DuPage Water Commission

AGENDA – Engineering and Construction Committee

X. **Resolution R-66-25:** A Resolution Awarding a Contract for the Construction of the West Transmission Main along Book Road from 75th Street to the ComEd R.O.W. (Contract TW-6/25 Section 1 (Book Road)) (**D. Construction, Inc. & Benchmark Construction Co., Inc. Joint Venture - $67,148,000)**

DUPAGE WATER COMMISSION
WATERLINK EXTENSION
CONTRACT TW-6/25 SECTION 1 WEST TRANSMISSION MAIN

SHEET NO. 119 of 199

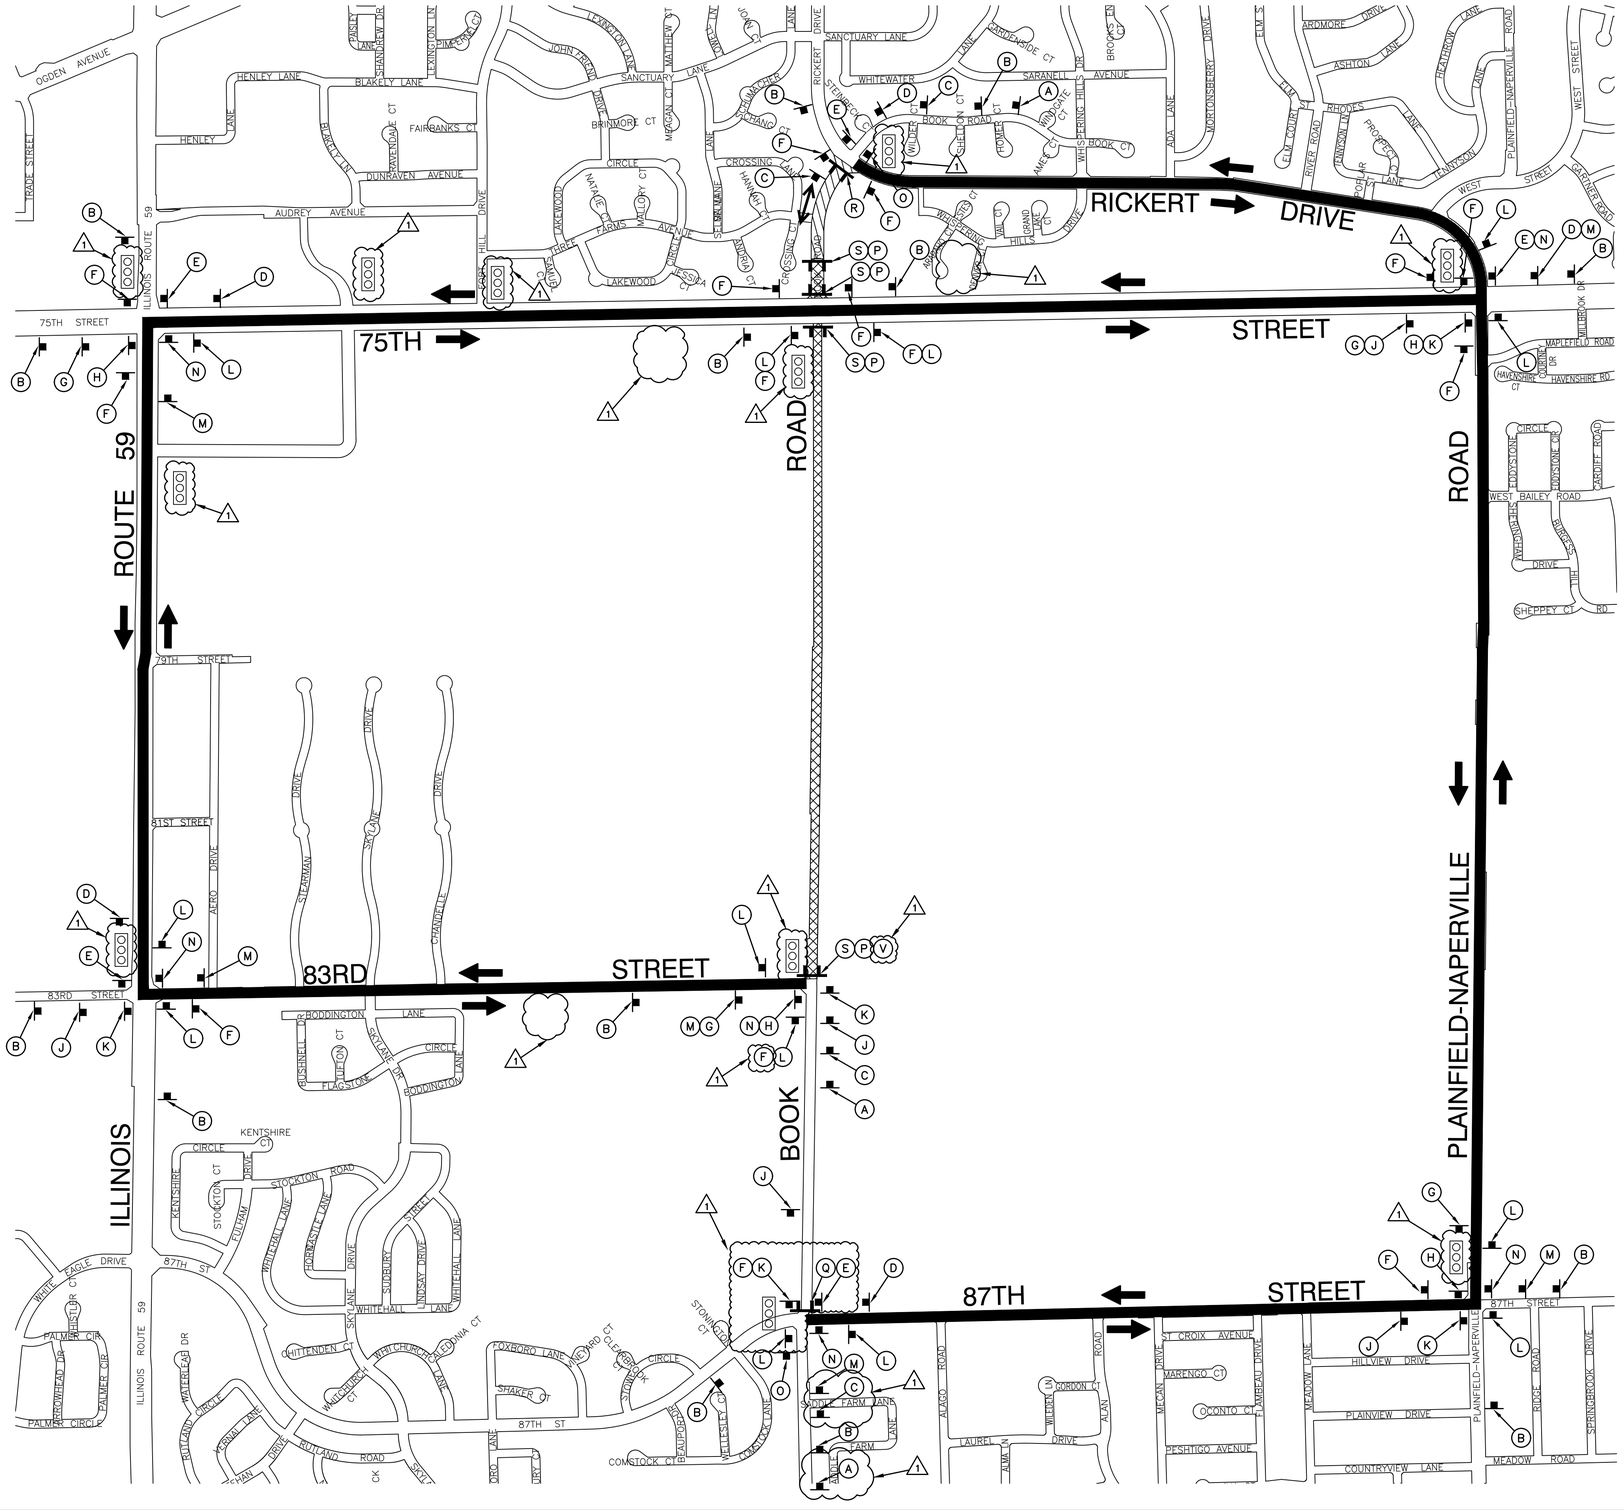
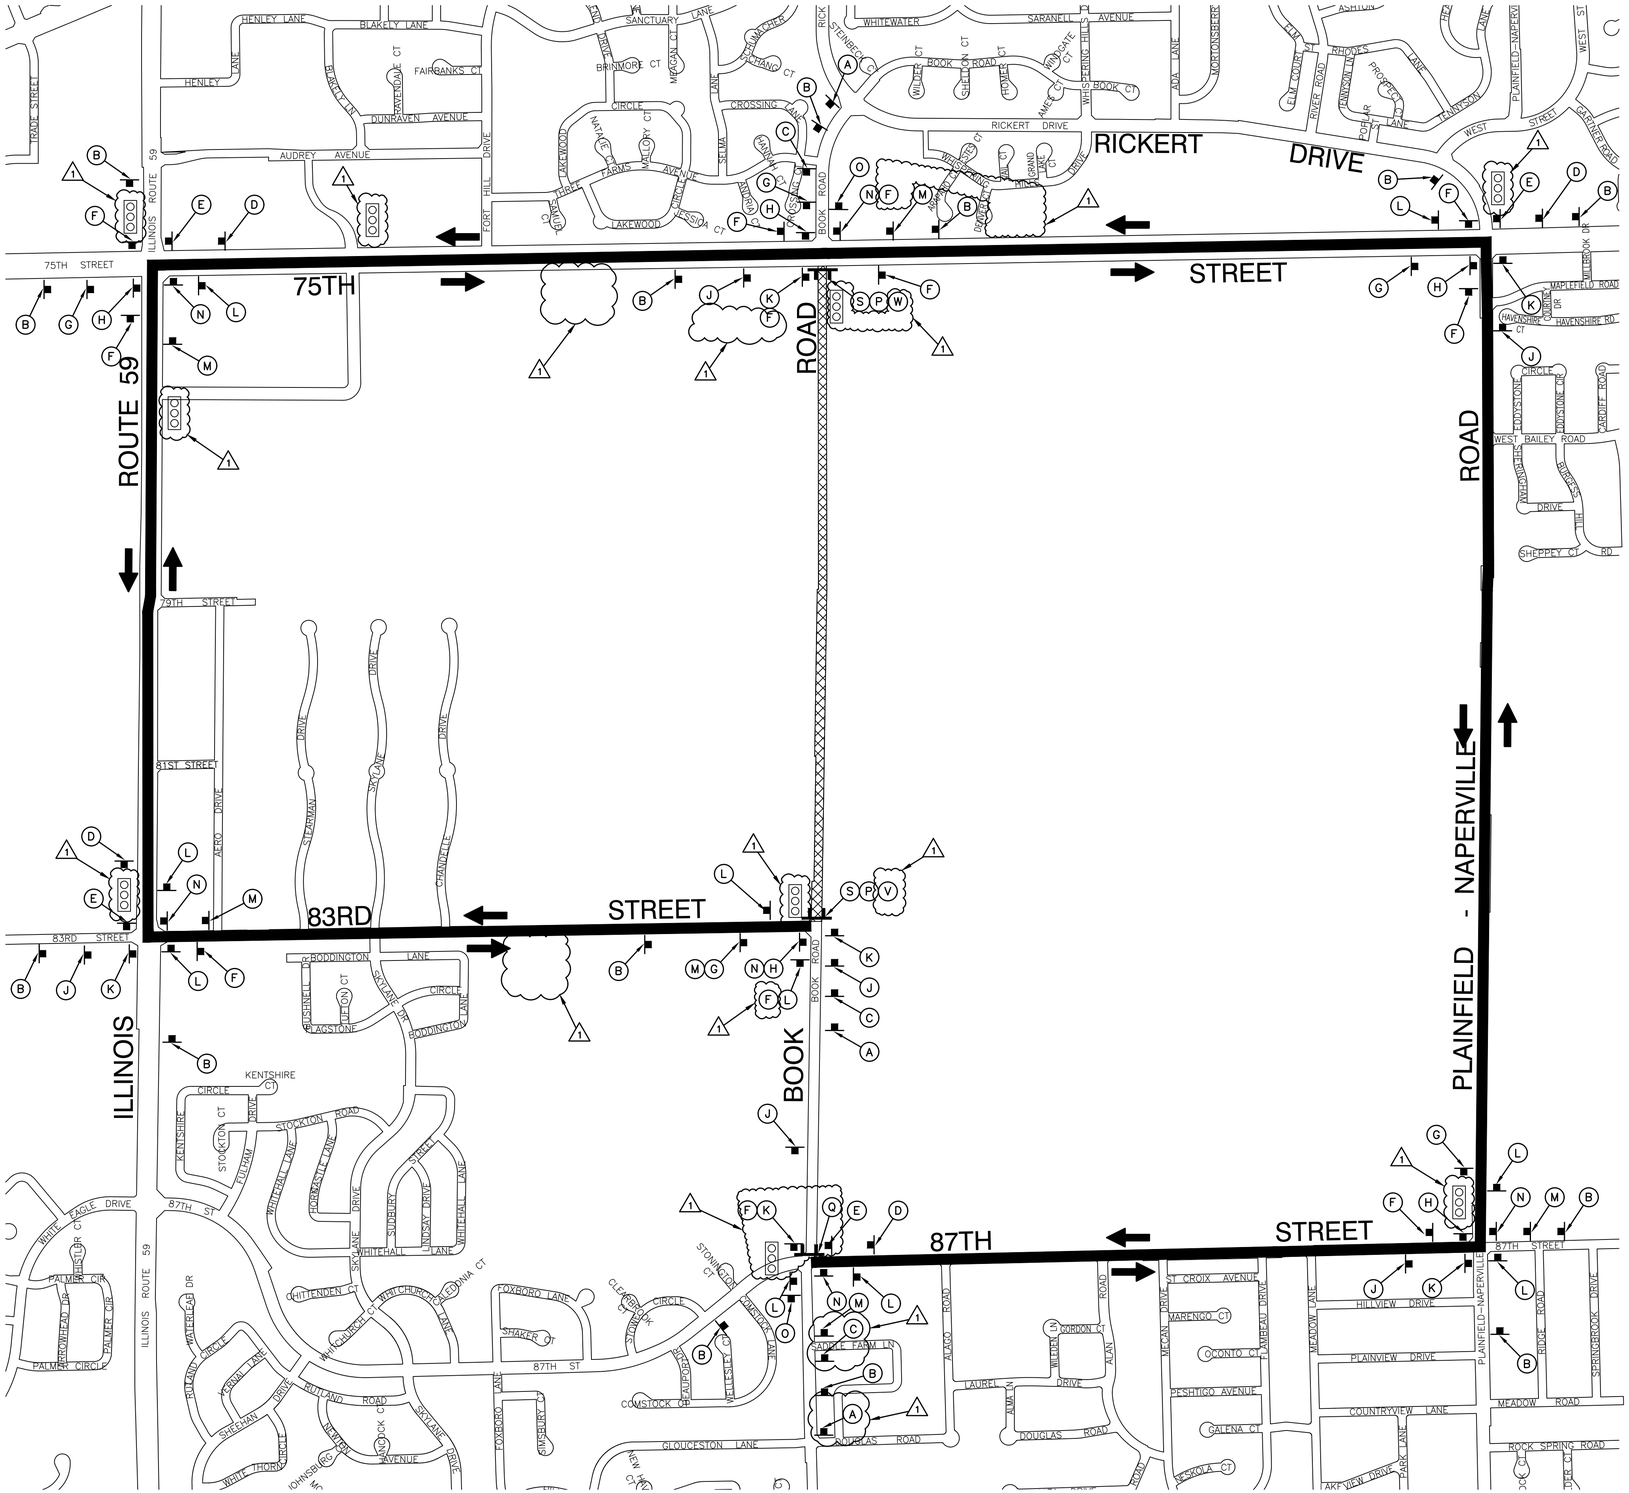
B. Replace Sheet 119 of 199 (Drawing MOT-001) to address comments from IDOT Permits for use of IL Route 59 for Detour Routes. Updated Sign Legends to clarify panels are Orange by adding (O) after sign codes. Added Additional Detour Signs "V" and "W" to sign legend. Added Legend Item to note Temporary Traffic Signal Timing locations to supplement Table on Sheet MOT-000. Revised Sign locations and types at various locations as clouded on the sheet.

DRAWING NO. MOT-002
SHEET NO. 120 of 199

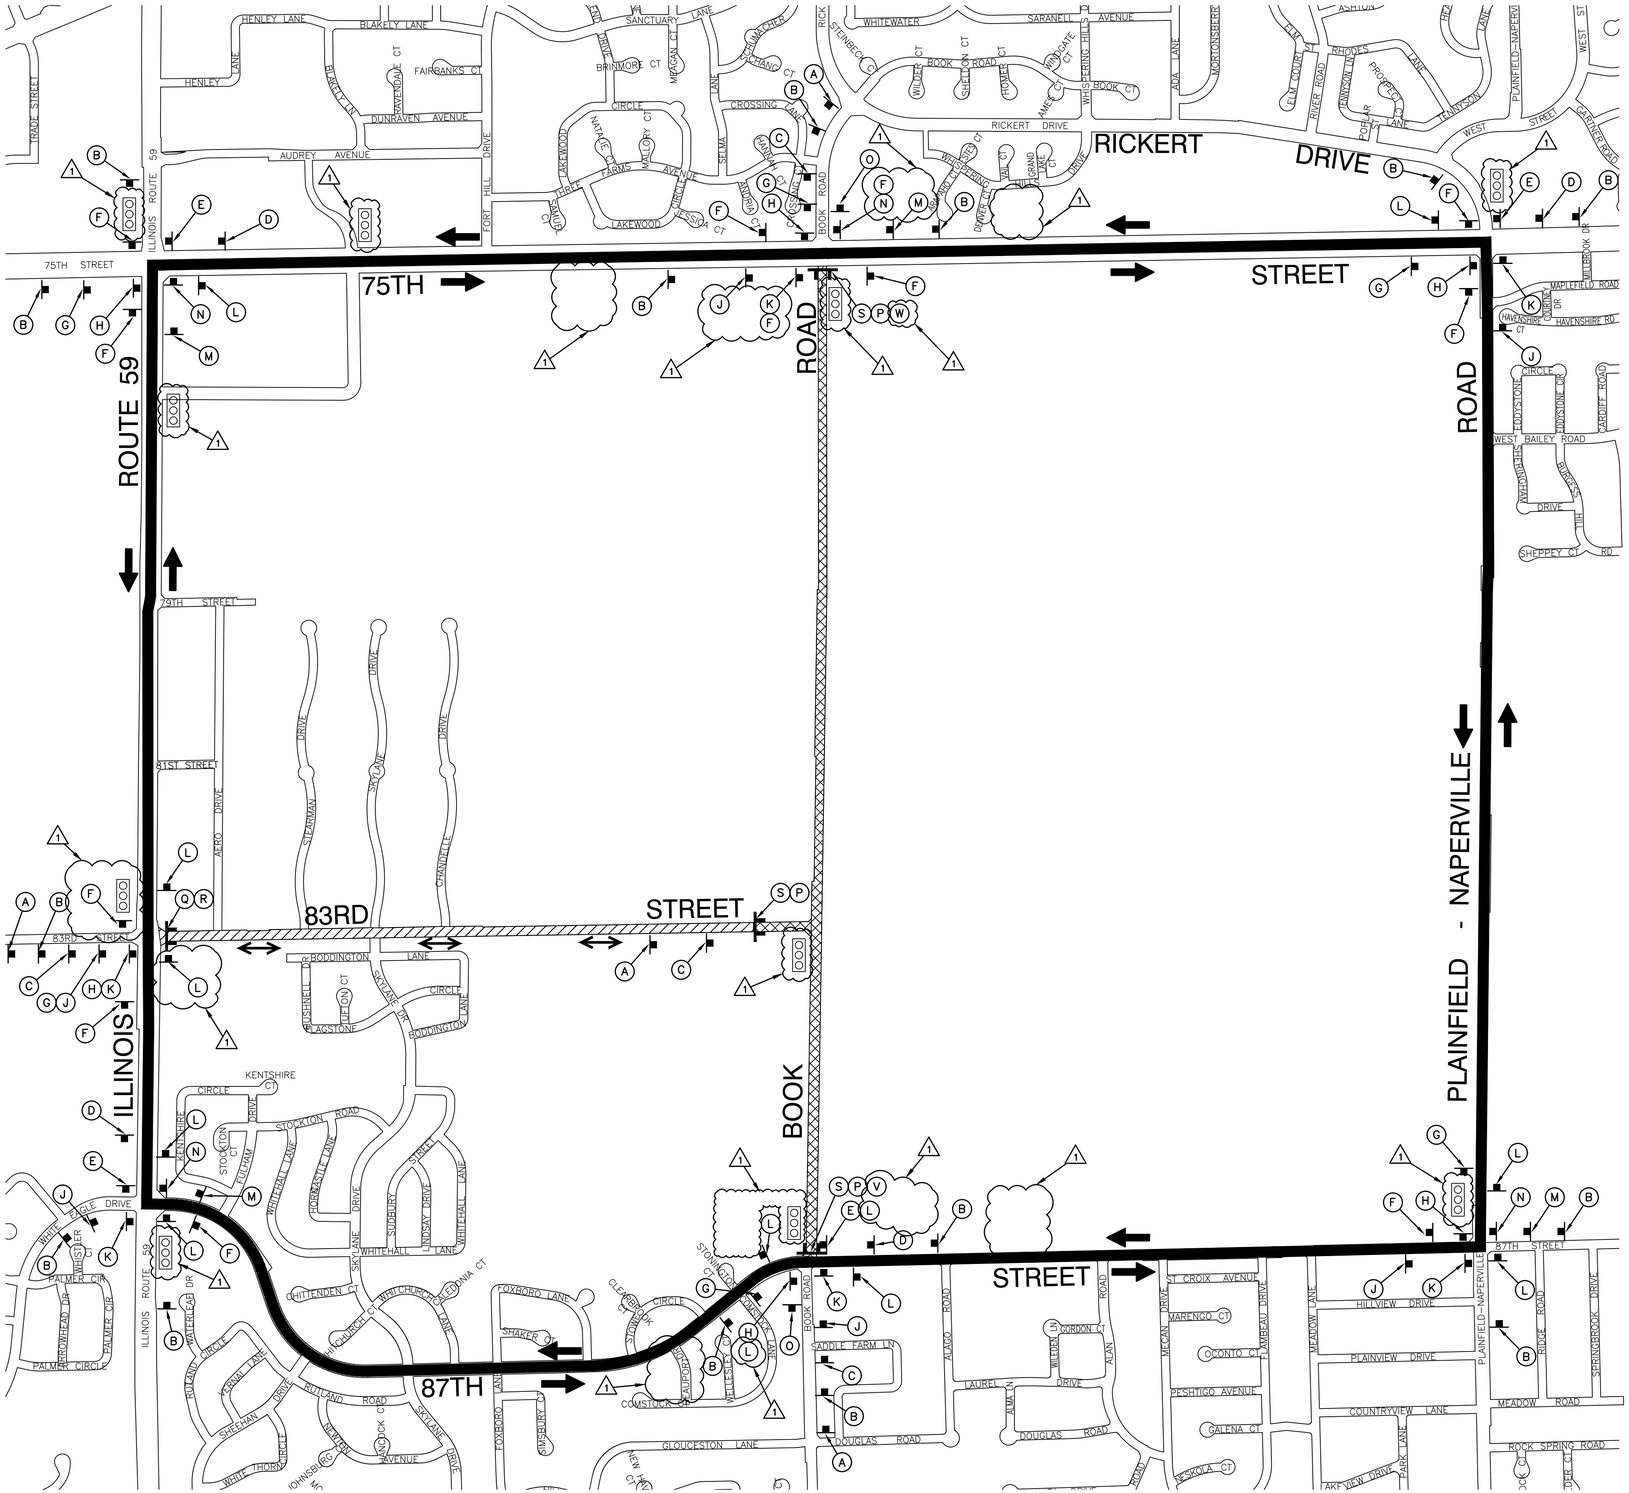
C. Replace Sheet 120 of 199 (Drawing MOT-002) to address comments from IDOT Permits for use of IL Route 59 for Detour Routes. Updated Sign Legends to clarify panels are Orange by adding (O) after sign codes. Added Additional Detour Signs "V" and "W" to sign legend. Added Legend Item to note Temporary Traffic Signal Timing locations to supplement Table on Sheet MOT-000. Revised Sign locations and types at various locations as clouded on the sheet.

DRAWING NO.	SHEET NO.
MOT-003	121 of 199

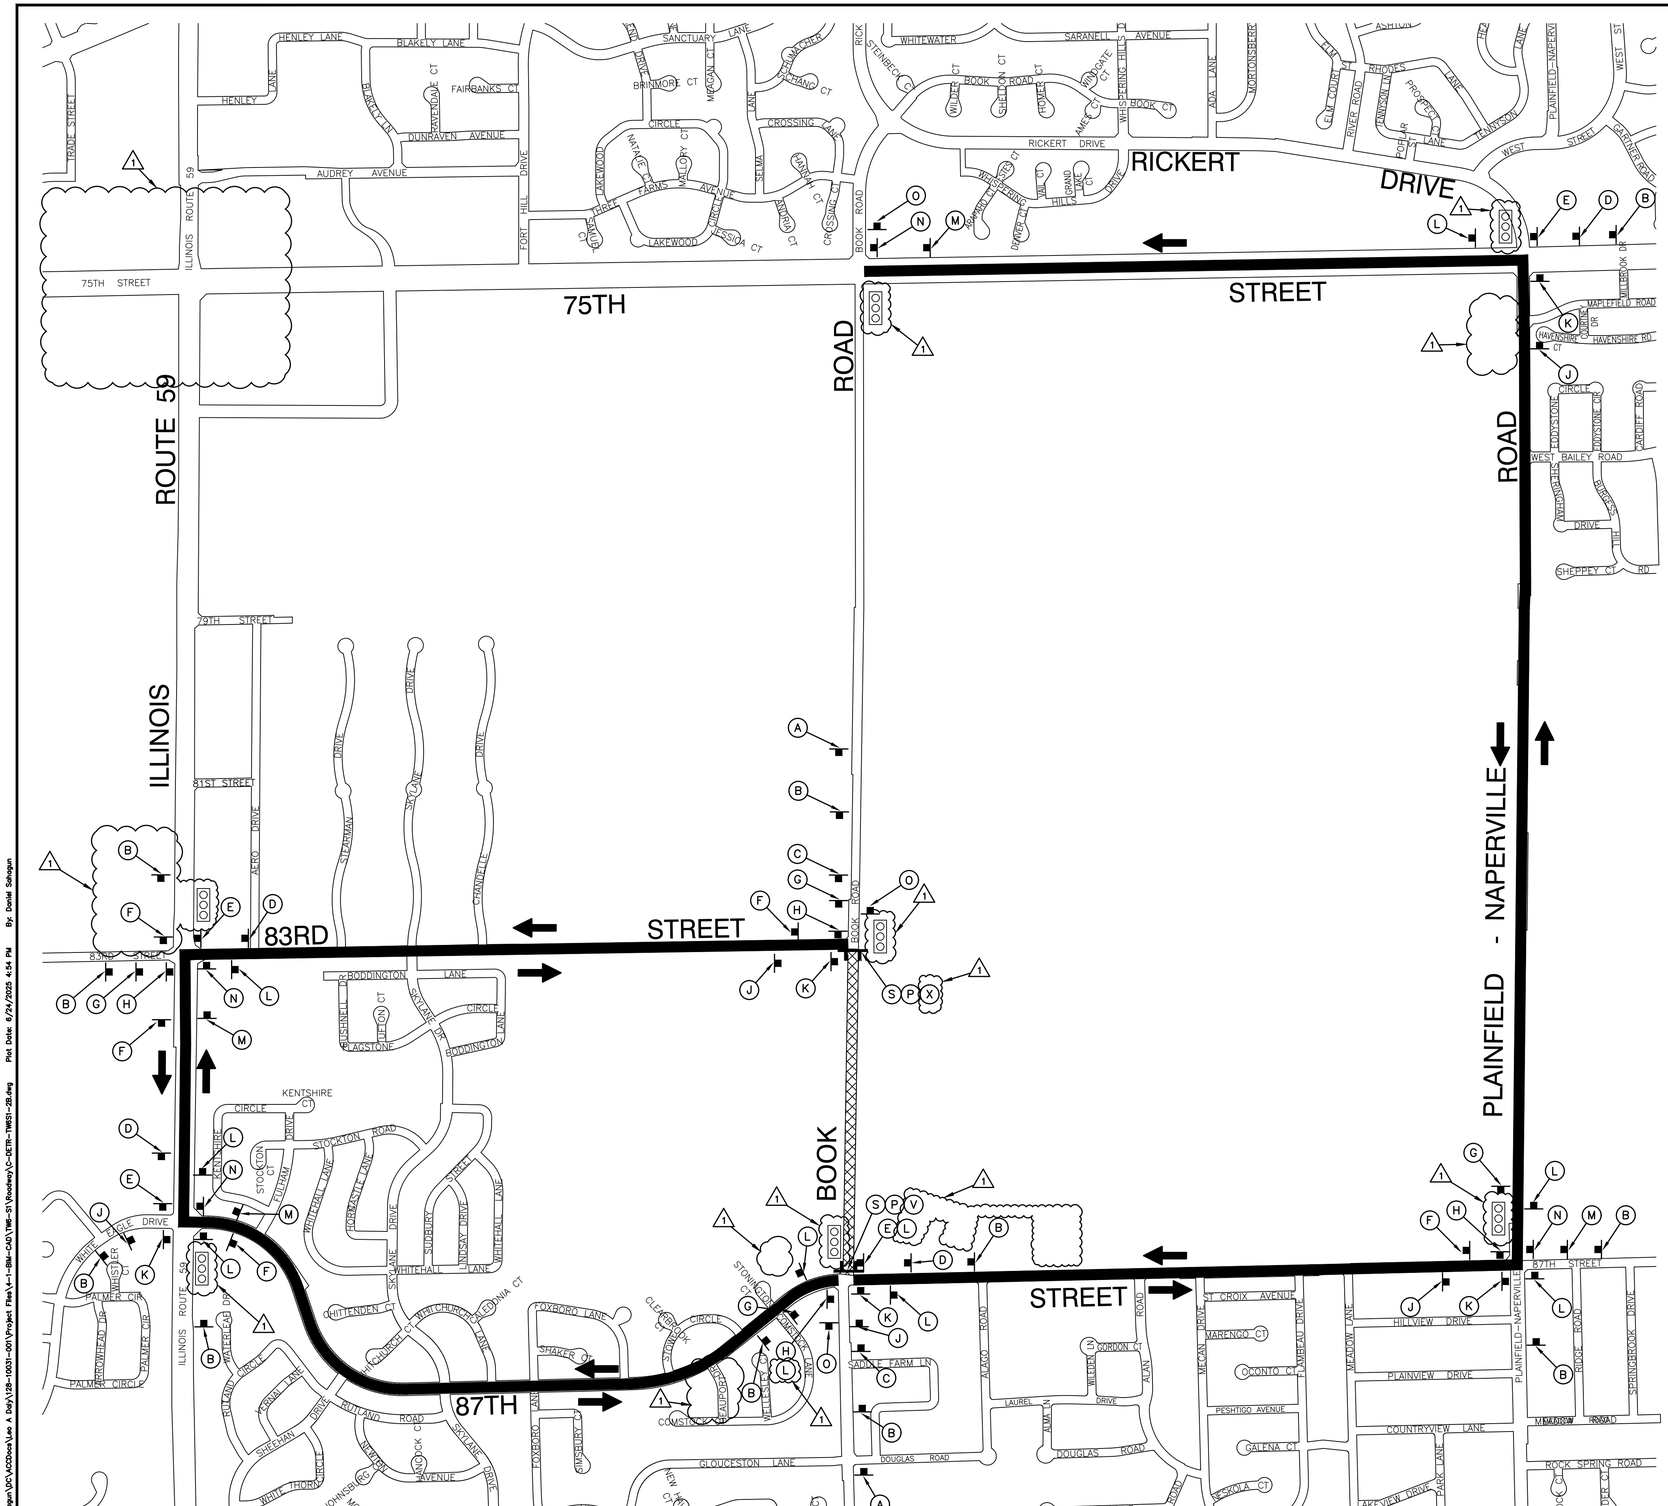
D. Replace Sheet 121 of 199 (Drawing MOT-003) to address comments from IDOT Permits for use of IL Route 59 for Detour Routes. Updated Sign Legends to clarify panels are Orange by adding (O) after sign codes. Added Additional Detour Signs "V" and "W" to sign legend. Added Legend Item to note Temporary Traffic Signal Timing locations to supplement Table on Sheet MOT-000. Revised Sign locations and types at various locations as clouded on the sheet.
